Project: Rancho 51 Accessibility Design Review
83272 51st Avenue
Coachella, CA 92236

Design Review

Parking Plan SHEET L-11.0

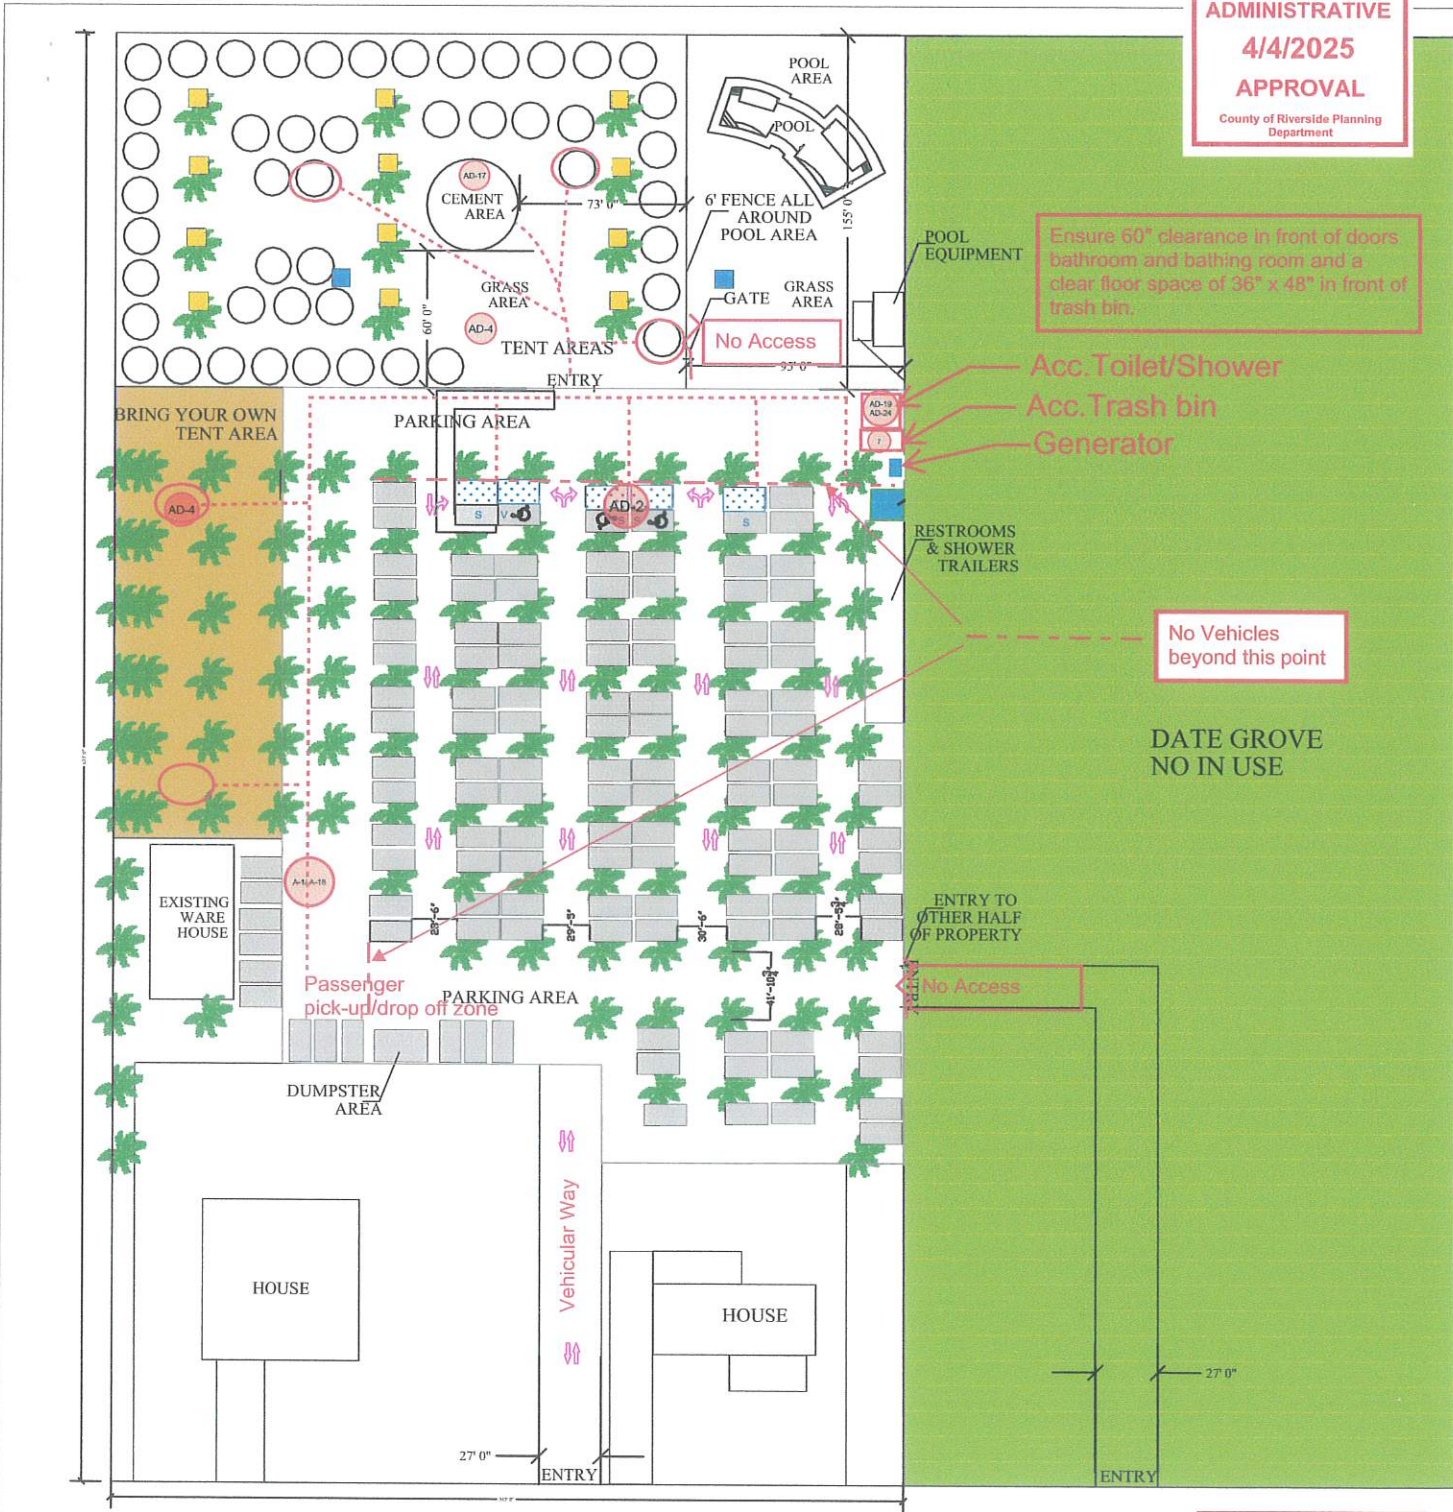
Ensure 60" clearance in front of doors bathroom and bathing room and a clear floor space of 36" x 48" in front of trash bin.
